SAFETY EVALUATION BY THE OFFICE OF NUCLEAR REACTOR REGULATION

EVALUATION OF SOIL-STRUCTURE INTERACTION ANALYSIS

AND THE PROPOSED APPROACH FOR GENERATION OF IN-STRUCTURE RESPONSE SPECTRA

OYSTER CREEK NUCLEAR GENERATING STATION

Figure 1. Recommended Shear Modulus Reduction and Damping Curves

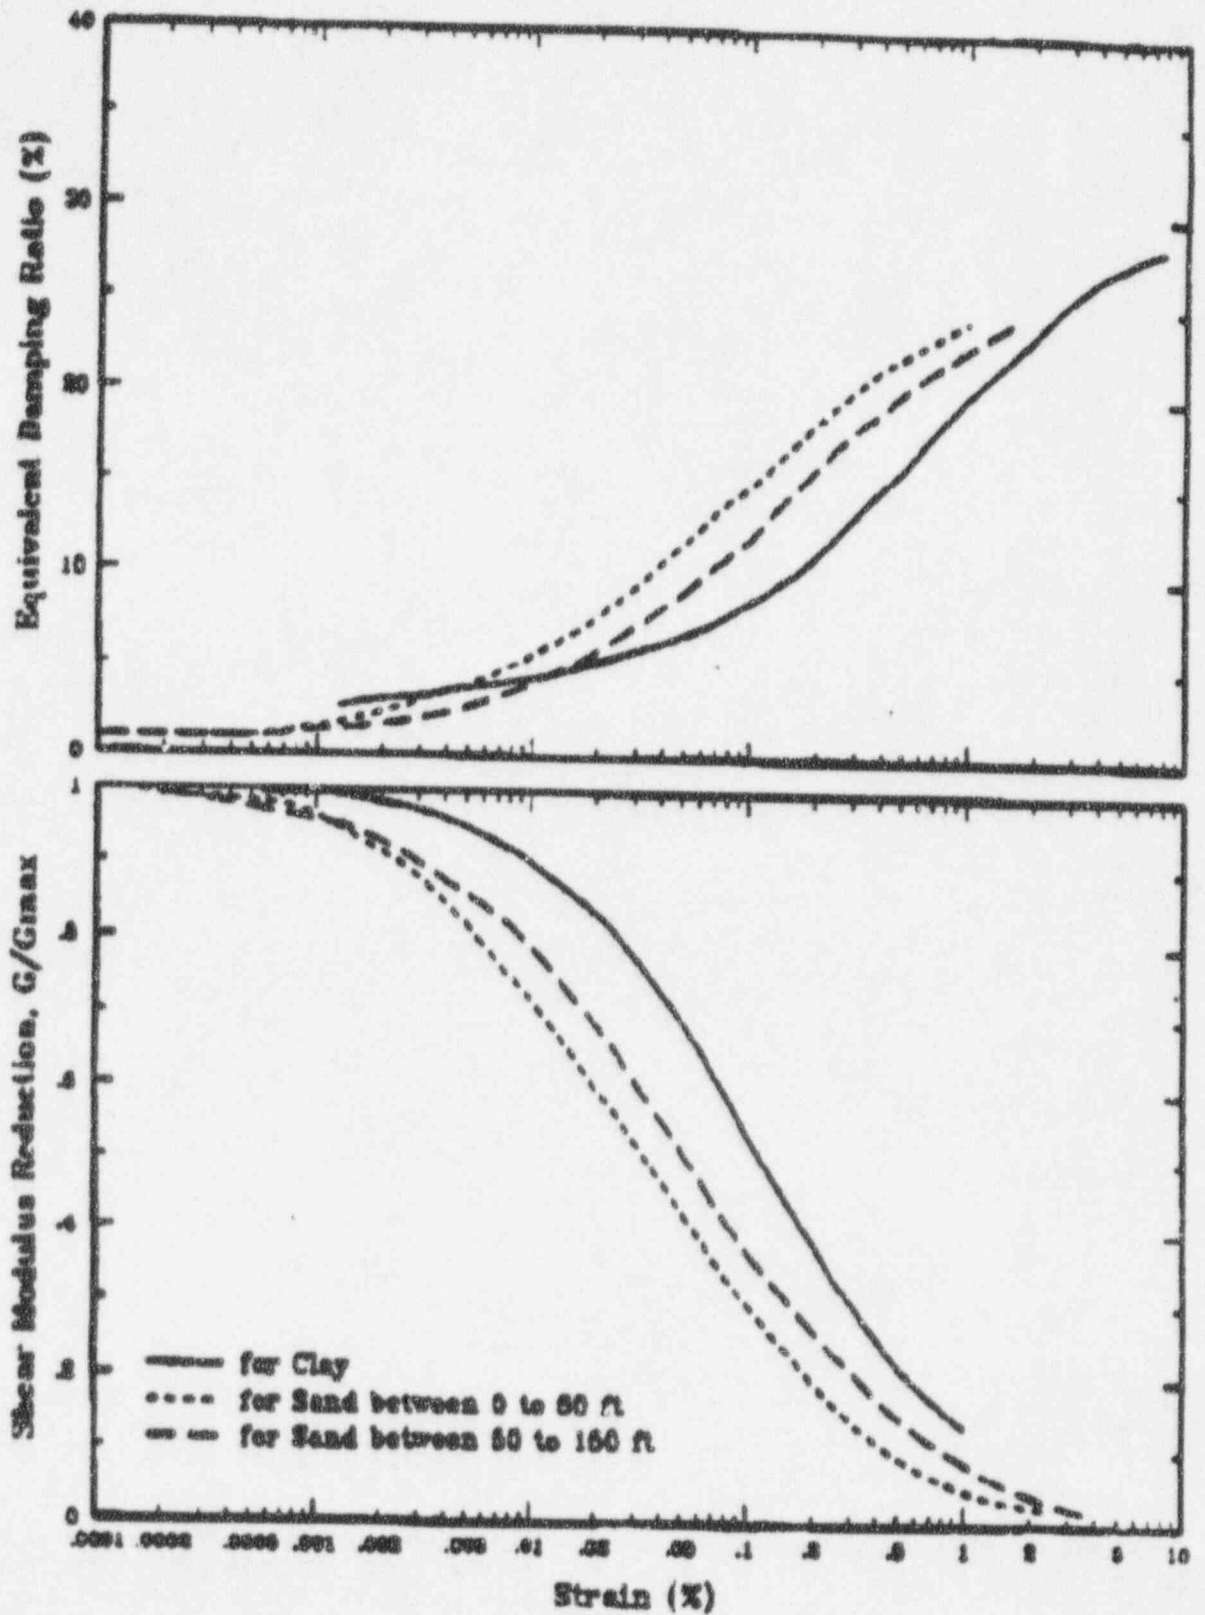
Based on the soil borings drilled during the construction stage (1964), and the results of standard penetration tests, the licensee's consultant, Geometrix Consultants, developed the soil profiles and dynamic soil properties to be used for the SSI analysis. A typical subsurface profile at the site consists of (in sequence of increasing depth) upper fine sand, upper clay, medium sand, lower clay, and a deep Kirkwood formation consisting of fine to medium sand. To define variations of shear modulus and material damping ratios with respect to shear strain, the licensee's consultants (Goemetrix and EQE) made use of the published relationships, general characteristics of the soil units and their experience with regards to the use of the strain-dependent properties. Figure 1 shows the relationships established for critical soil layers. The staff recognizes that the degradation curves utilized by EQE for upper 50 ft of sand layers are not as conservative as the recent findings (Refs. 9,10) at specific sites.

In response to the request for information on this issue, the licensee justified (Ref. 11) the use of the proposed degradation curves by pointing out the differences in the characteristics of the sand-soil layers at the OCNGS site with those at the sites investigated in References 9 and 10. The licensee also emphasized that for the deeper sand layers (> 50 ft), to account for the effects of confining pressures, more conservative degradation curves were used. Considering other conservatisms (as per SRP Section 3.7.2) used in the analysis, the staff finds the use of the proposed soil properties acceptable.

Figure 2. Typical Enveloping Broadened Spectrum

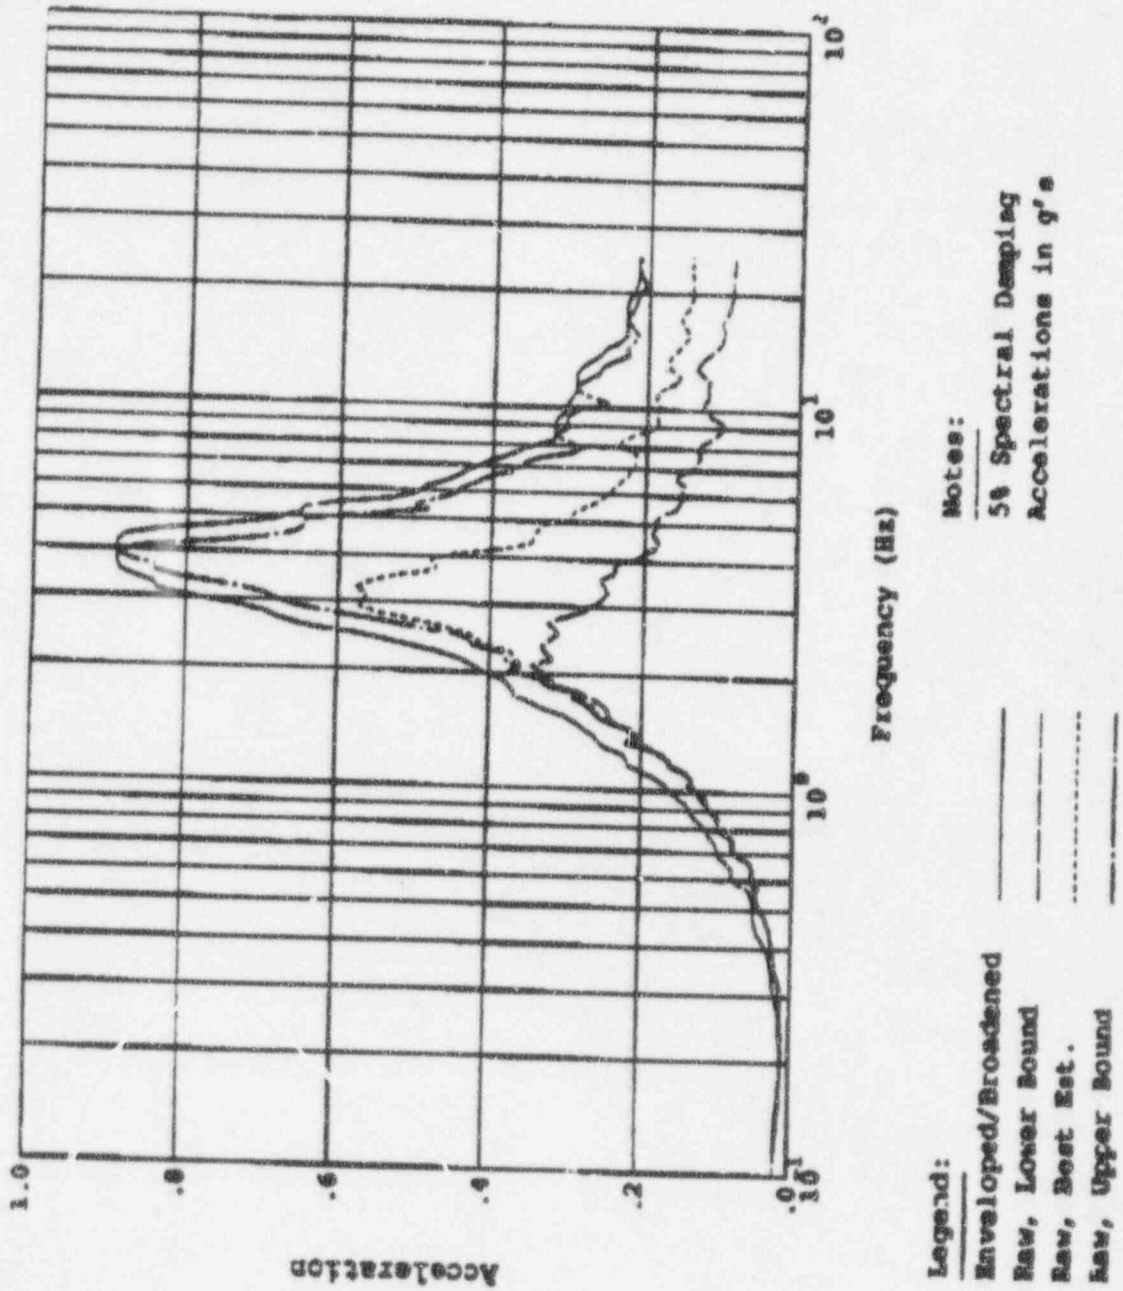
Based on the seismic input at 3 ft below the grade level, and the three high-strain soil profiles, EQE generated free-field time histories and associated response spectra at 5 percent damping at the foundation level using the computer program SHAKE. The spectra for the three soil profiles were enveloped (in each direction) and compared with the 60 percent of the spectra at the surface. If, in any frequency range, the enveloped spectrum is less than the 60 percent of the corresponding surface spectrum, the surface time history was modified to increase the power in the frequency range of deficiency. The modified time histories are proposed to be used for the SSI analysis and for generating IRS. The staff finds the proposed method consistent with the intent of SRP Section 3.7.2, and is acceptable for generating in-structure response spectra.
